800GBASE-LR1 PMD specification proposals

(Supporting contribution for comments #550 thru #558)

P802.3dj Interim Meeting, Hamburg, Germany, Sep 2024

Clause 185 PMD Reliability Requirements

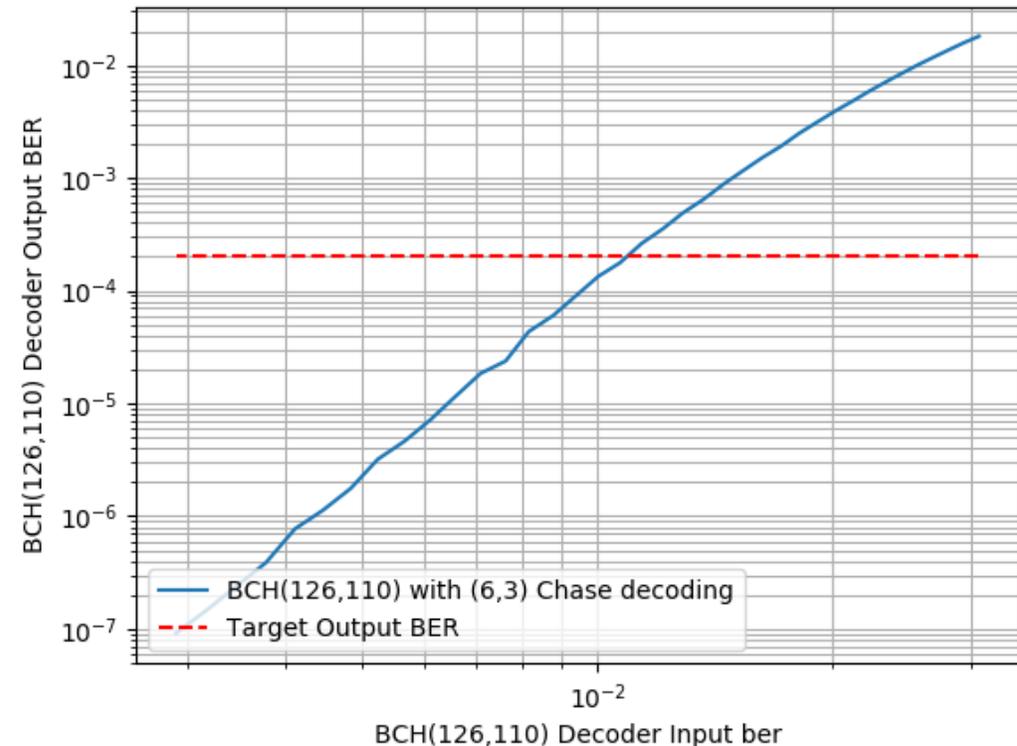
- Proposed resolution for Comment #550:

Replace

“A PMD is expected to meet <metric TBD>.”

with following text:

“A PMD is expected to meet the FEC codeword error ratio requirement of less than 1.45×10^{-11} in 174A.5 with a BER of 1×10^{-2} at the output of the DP-16QAM demapper in the inner FEC sublayer.”
